SUBJECT: Consider Approval of a Building Expansion for Metro Heating and Cooling, 2303 Atlantic Street North

Engineering Plan Review

PROJECT: **Metro Heating and Cooling – 2303 Atlantic Street North**
PROJECT NO: **16-34**

SC 4.2

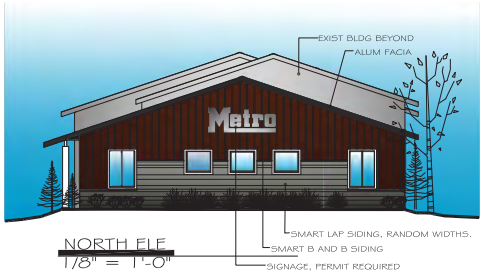
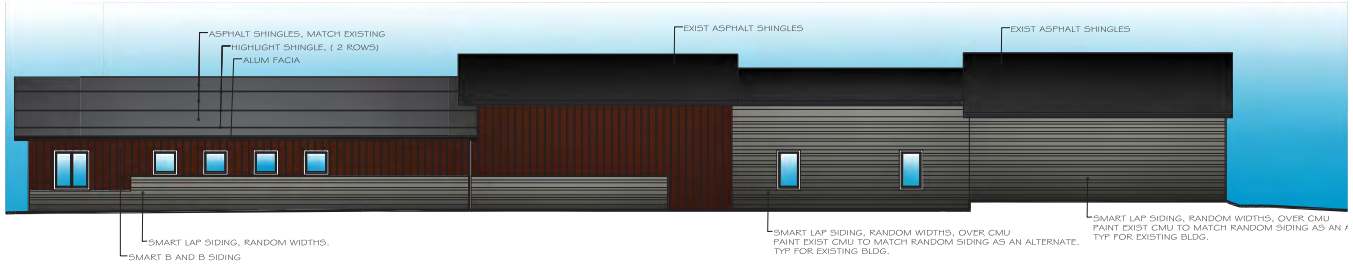
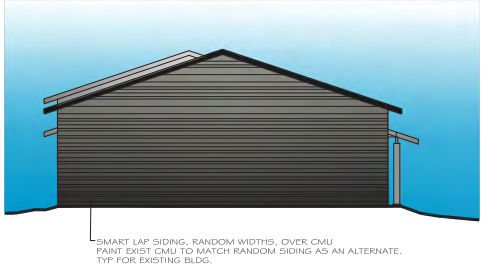
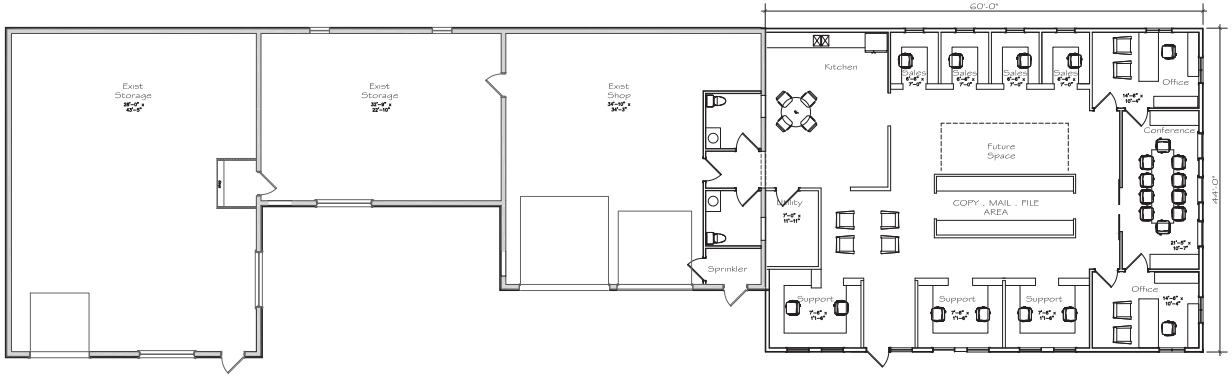
The exterior of the proposed addition will be sided with a combination of Smart Lap siding, and Board and Baton siding. The roof will be asphalt shingles, with subtle highlight color strips integrated into the shingle patterns. The existing building is proposed to be either painted to match the new colors of the addition, or a random lap siding matching the office portion will be applied over the concrete block. Colors for the siding will be will be dark grey and dark red, with a black and grey roof.

DESIGNED FOR: METRO HEATING & COOLING
LANDSACPE PLAN

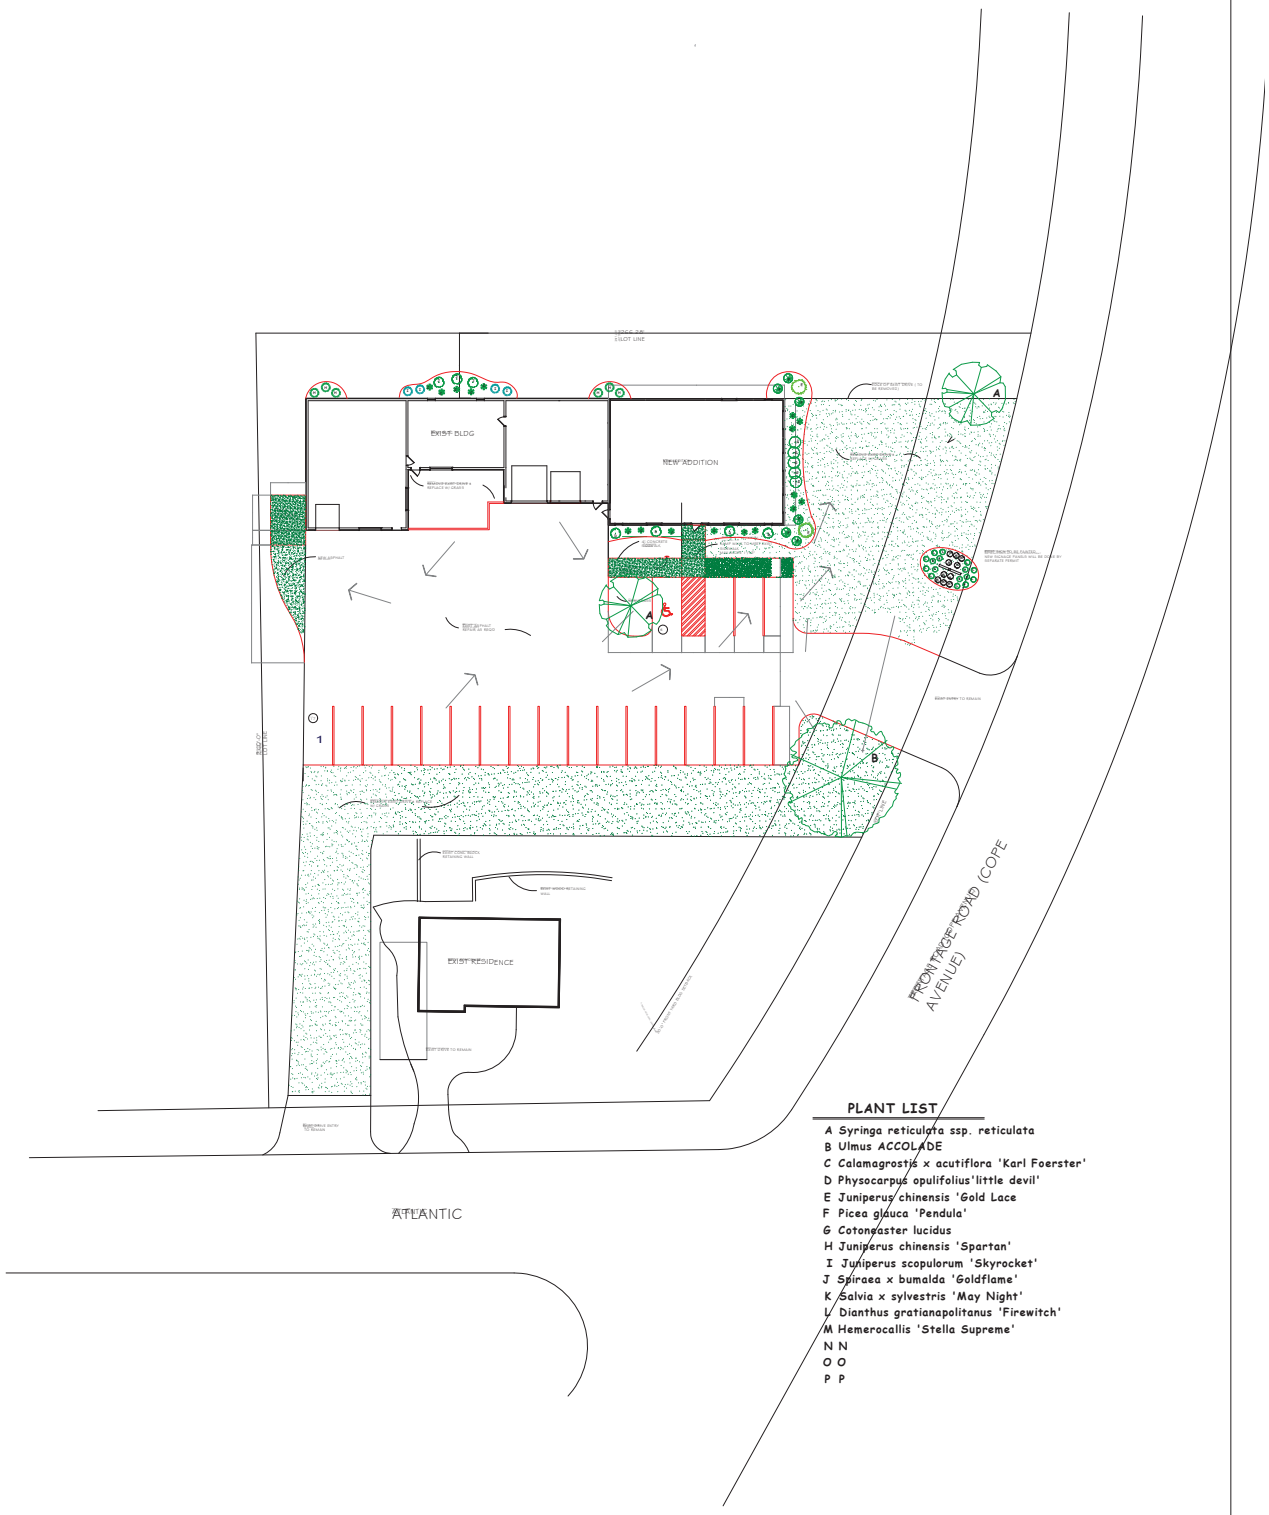
The applicant is not proposing to remove any trees on site. The landscape plan indicates three new trees will be planted as well as several shrubs and other ground level plantings throughout the site. These elements combined with the conversion of asphalt to green space will work to greatly improve the overall aesthetic of this property.
